South Texas Project Electric Generating Station P.O. Box 289 Wadsworth, Texas 77483

South Texas Project
Units 1 and 2
Docket Nos. STN 50-498, STN 50-499
Response to Requests for Additional Information for the
Review of the South Texas Project, Units 1 and 2,
License Renewal Application – Set 26 (TAC Nos. ME4936 and ME4937)

STP Response to Requests for Additional Information

The staff has completed its evaluation of the response to request for additional information (RAI) B2.1.37-4 related to the Selective Leaching of Aluminum Bronze plant-specific aging management program (AMP). As a result of this review, there are several open questions.

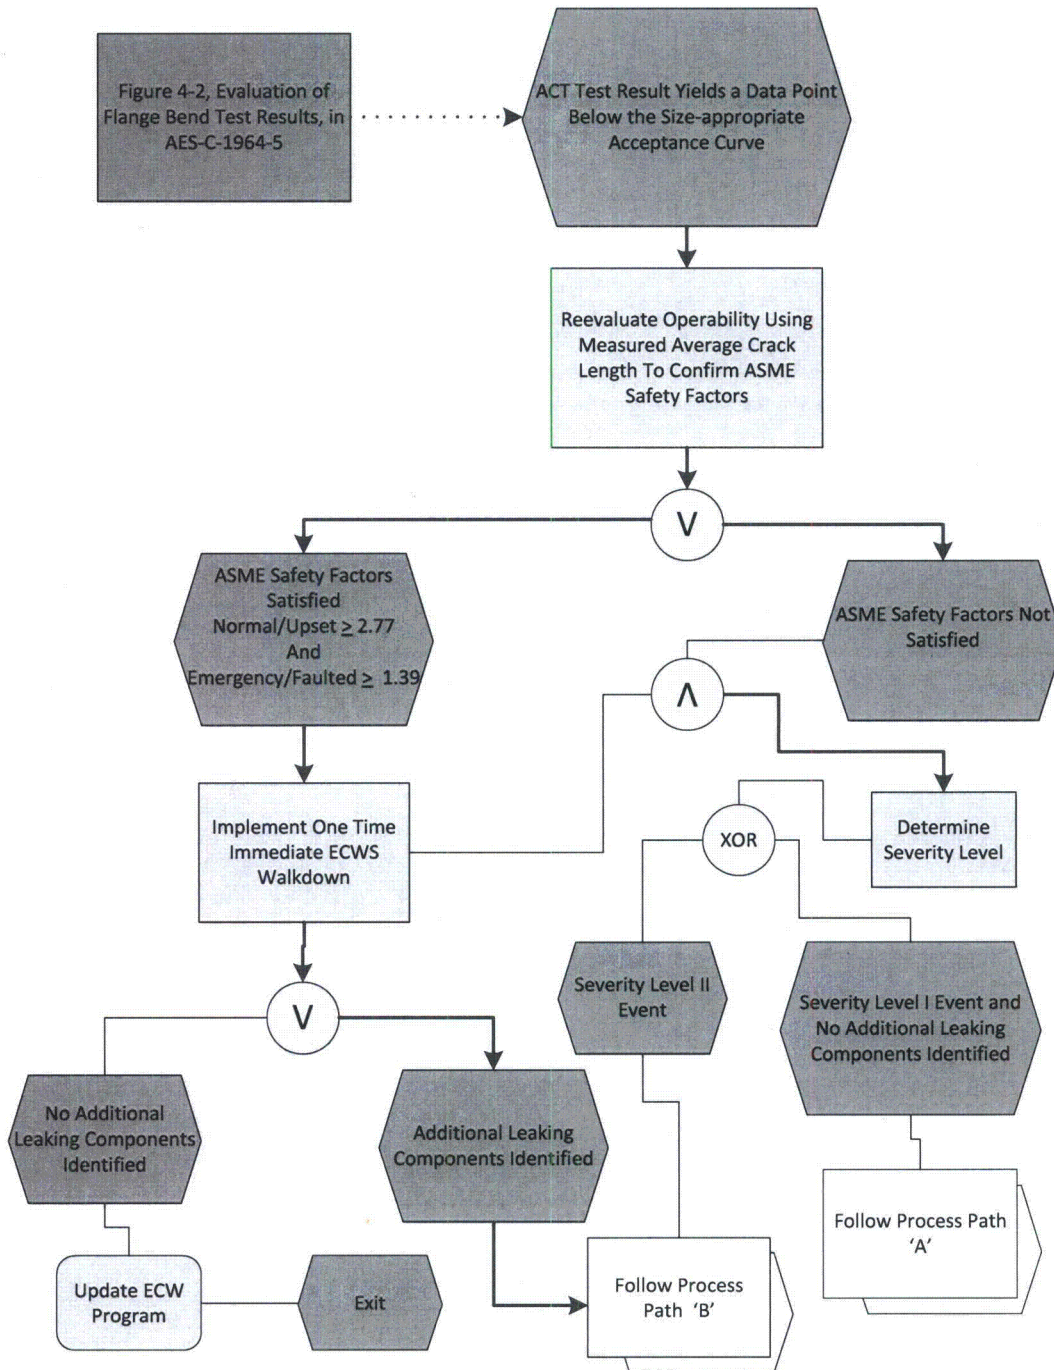
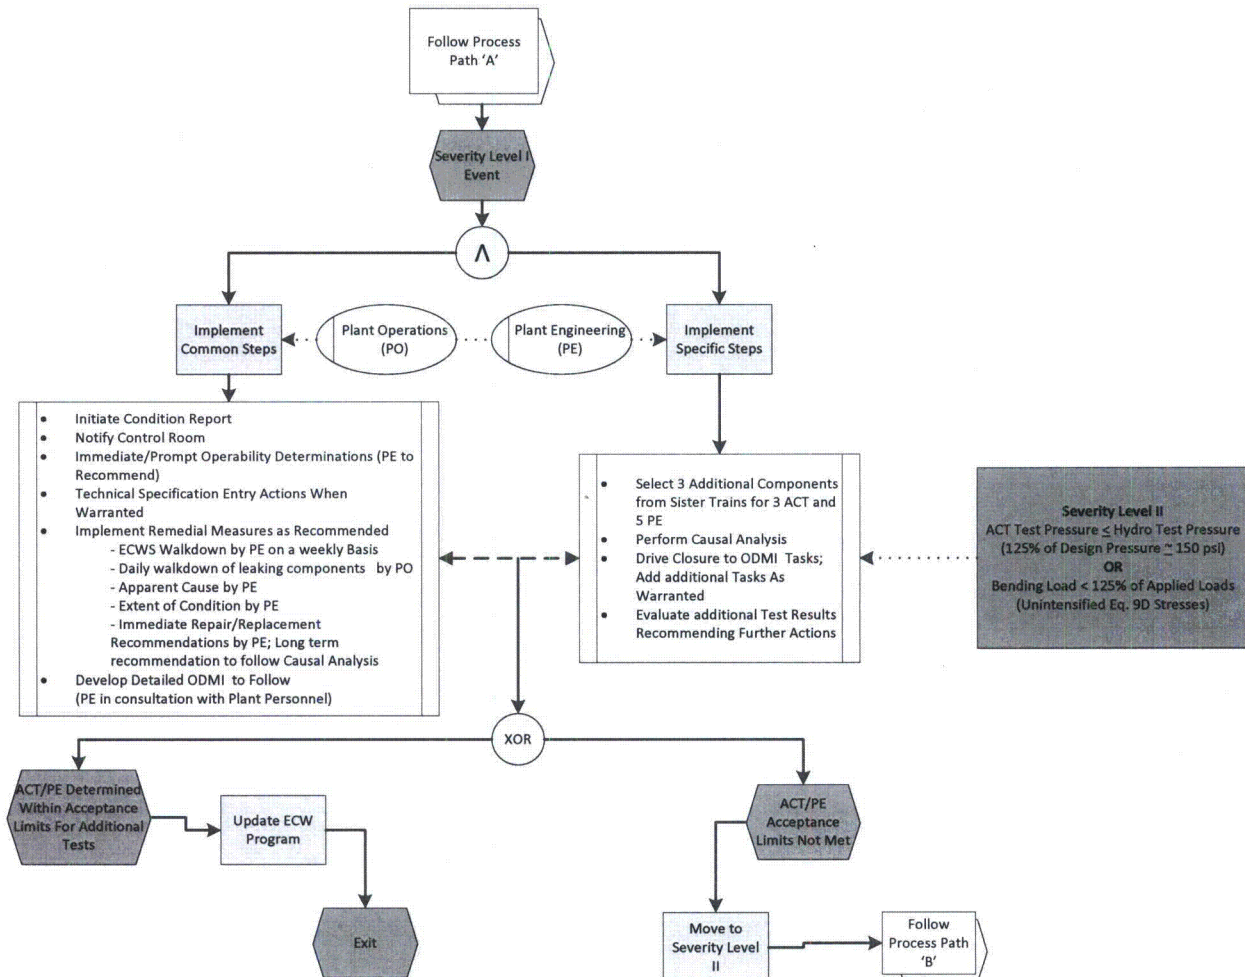
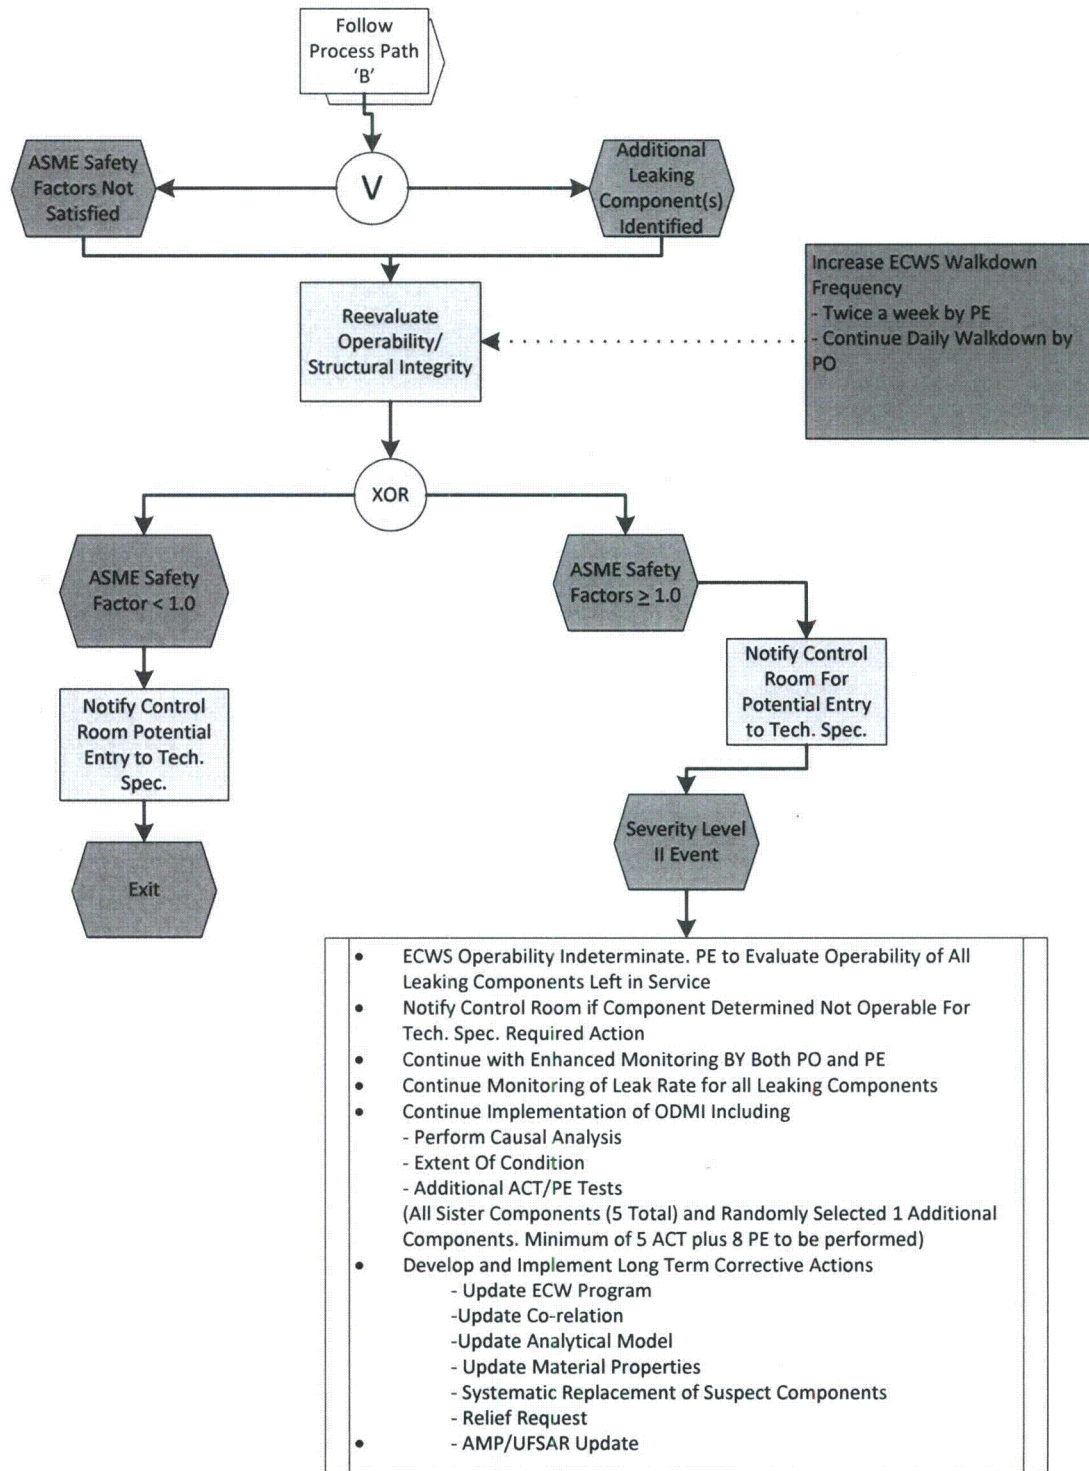
- An ACT test result yields a data point below the size-appropriate acceptance curve (e.g., Figure 4-2, "Evaluation of Flange Bend Test Results," in AES-C-1964-5)

The below listed criteria determines the severity levels.

Severity Level	Criteria	Number of Components to be Tested
II	The ACT pressure \leq hydro test pressure (125% of Design Pressure \approx 150 psi) and Bending load \leq 125% of applied loads (unintensified Eq. 9D stresses)	5 ACTs sister component from remaining trains 1 ACT randomly selected component from affected train 8 PEs
I	The ACT pressure \leq hydro test pressure (125% of Design Pressure \approx 150 psi) or Bending load \leq 125% of applied loads (unintensified Eq. 9D stresses)	3 ACTs 5 PEs

Specific remedial measures are based on severity as recommended by the following Decision Flowcharts.

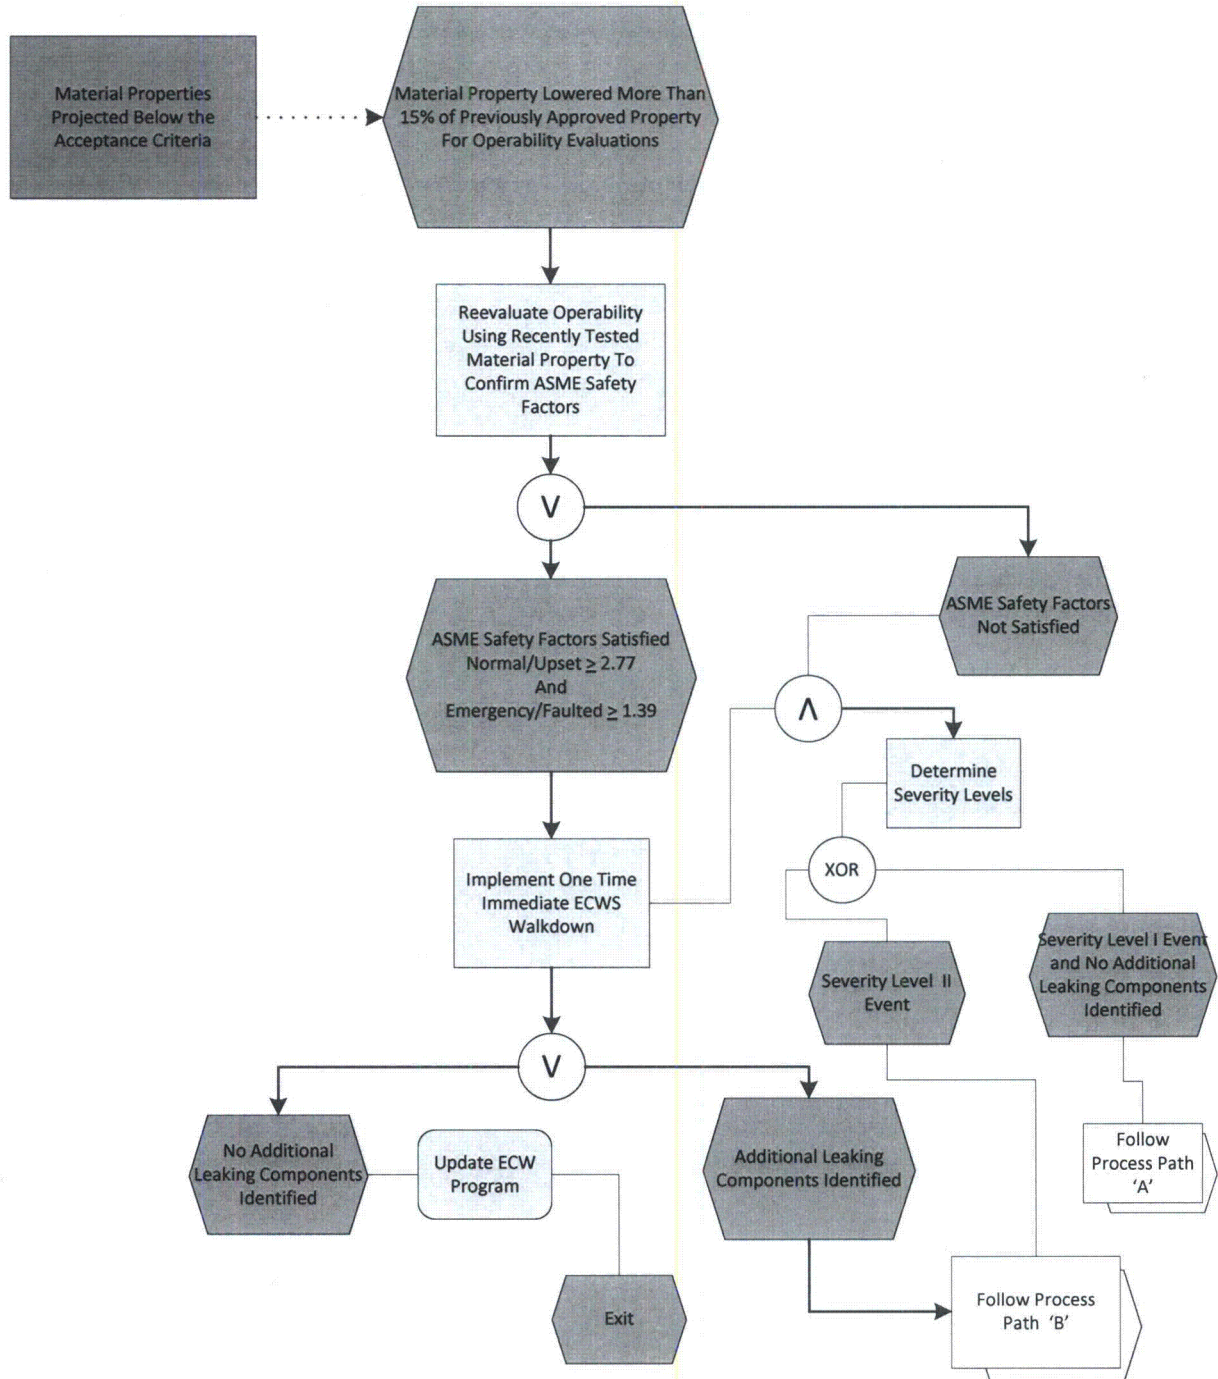
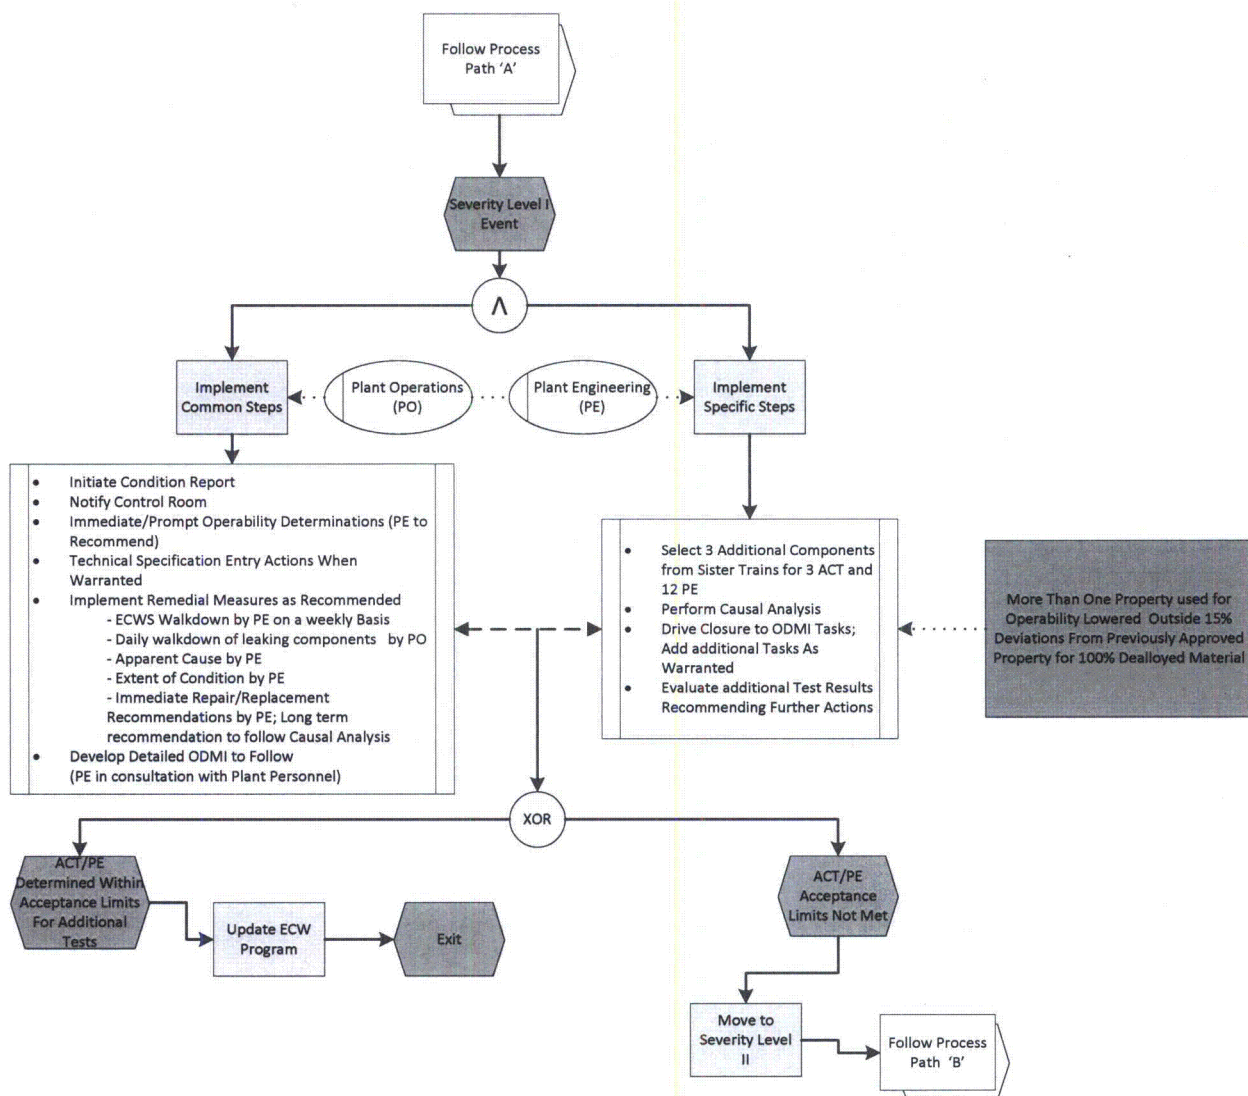
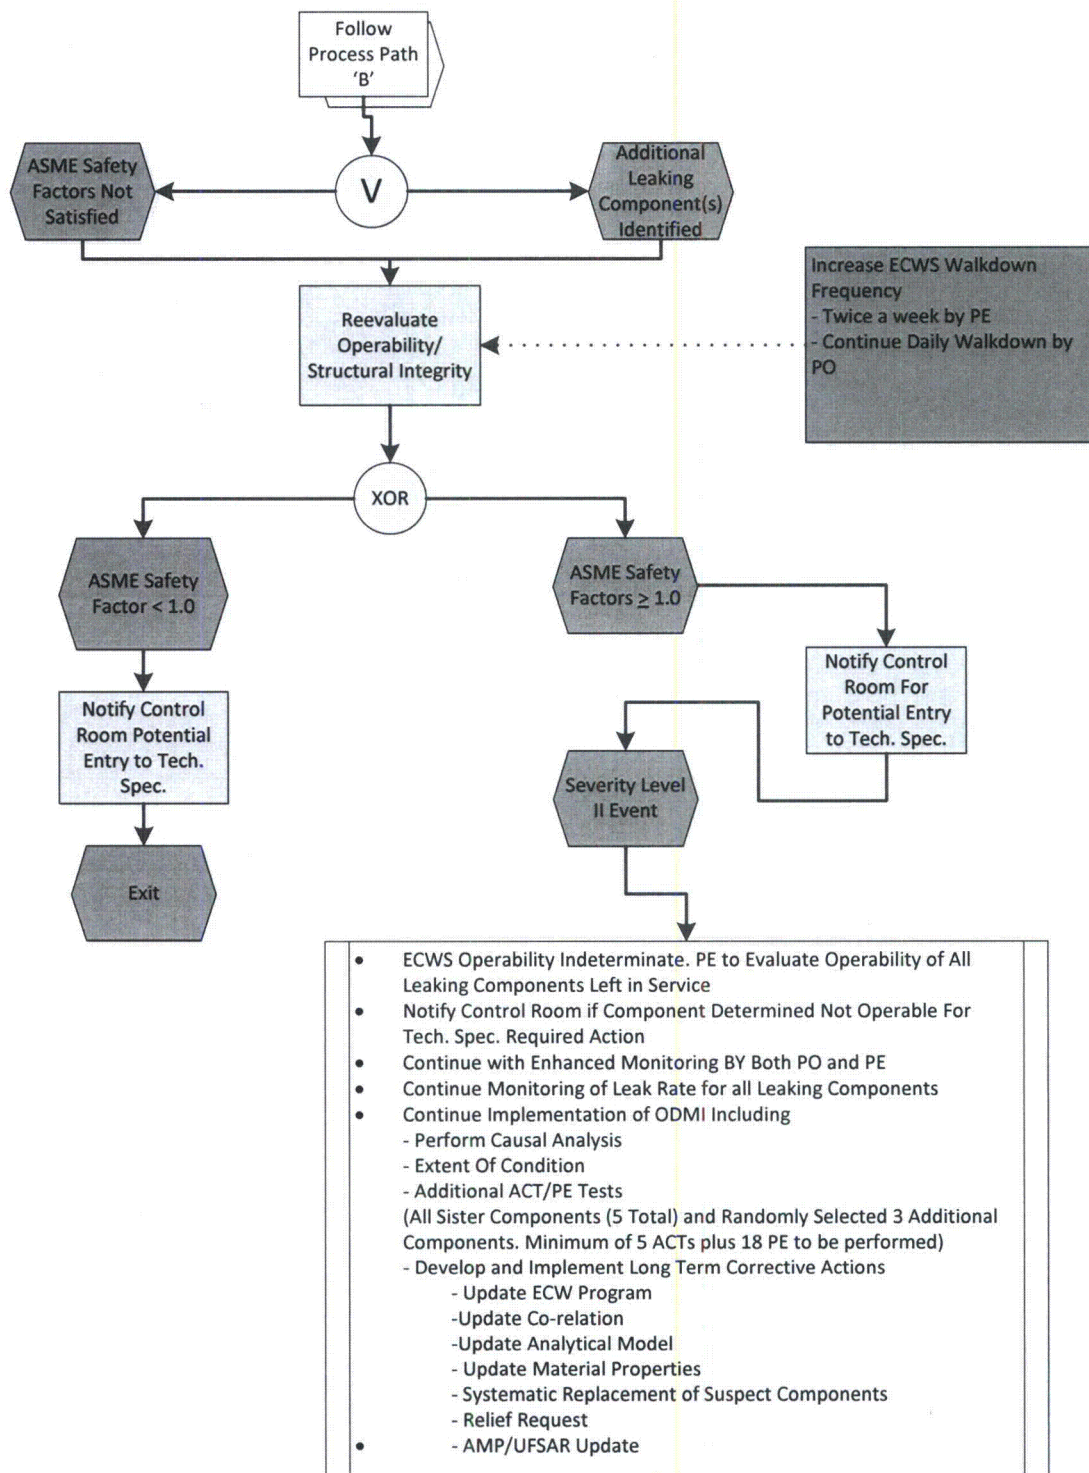
- PE or ACT results demonstrate a trend where, due to continuing dealloying, tensile strength, yield strength, or fracture toughness properties are projected to be below the acceptance criteria prior to the end of the PEO. It is the staff's position that the initial testing used to establish reasonable assurance and the continuing confirmatory testing can provide a timely projection of degraded mechanical properties, and all susceptible components should be repaired or replaced prior to the as-found properties or the as-trended properties fall below the acceptance criteria.

The deviation in the post-test material properties will determine severity levels.

Severity Level	Acceptance Criteria	Number of Components to be Tested	Probable Actions
II	Continued deviation more than 15% from previously measured properties (from severity I tests) for 100% dealloyed material	5 ACTs and 18 PEs randomly selected component from affected train	<ul style="list-style-type: none">- Enter Technical Specification.- Notify Control Room.- Seek temporary relief from the NRC for continued operation until root cause can be determined
I	More than 15% deviation from previously measured properties for 100% dealloyed material	3 ACTs 12 PEs	<ul style="list-style-type: none">- Enter Technical Specification.- Notify Control Room.- Seek temporary relief from the NRC for continued operation until root cause can be determined.- Additionally tests are required to confirm potential entry to Severity Level II

Specific remedial measures are based on severity as recommended by the following Decision Flowchart.
